Product Change Notification

Date Issued :	October 18, 2022	PCN Number :	512771
Reason for Change :	Equipment Transfer, Production Transfer or Rearrangement		
Description of Change :	This notification is to inform you about an equipment transfer that has been used to manufacture impacted part(s). Equipment has been moved to different site/ location/ premises. No changes will be made to product part, fit nor function as part of this change.		
Assessment of Change :	No change to parts - Form/Fit/Function Dimension analysis		
Planned Implementation Date :	April 18, 2023		
Sample Availability Date:	March 17, 2023		
Internal Molex Qualification Date :	March 17, 2023		
Last date to request Samples by Customer : March 27, 2023			
Traceability Code Markings / Date :	Date code

Guadalajara 2

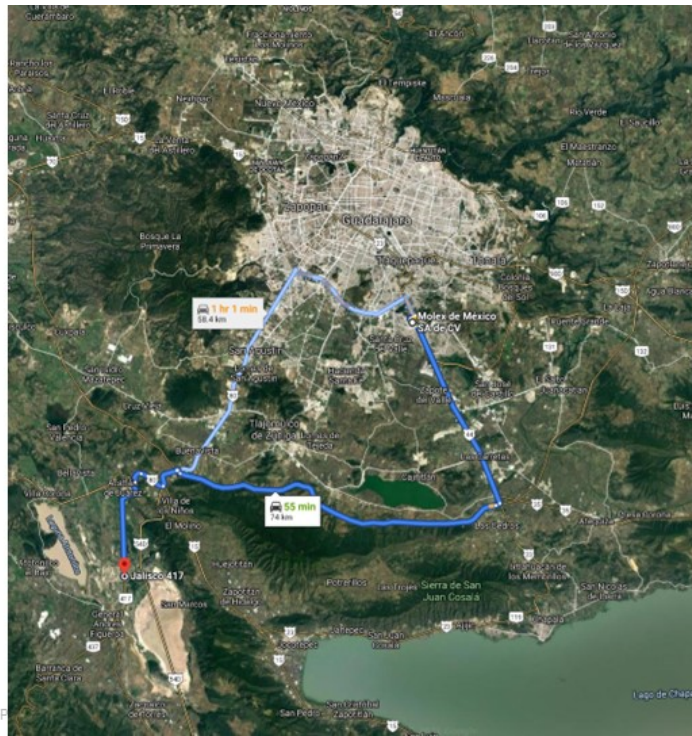
- Located in Centro Logistico Jalisco Industrial Park
- 1 hour from existing Guad1
- Initial build will contain Molding, Assembly, and Reliability Testing capabilities
- A new Distribution Center services Guad2
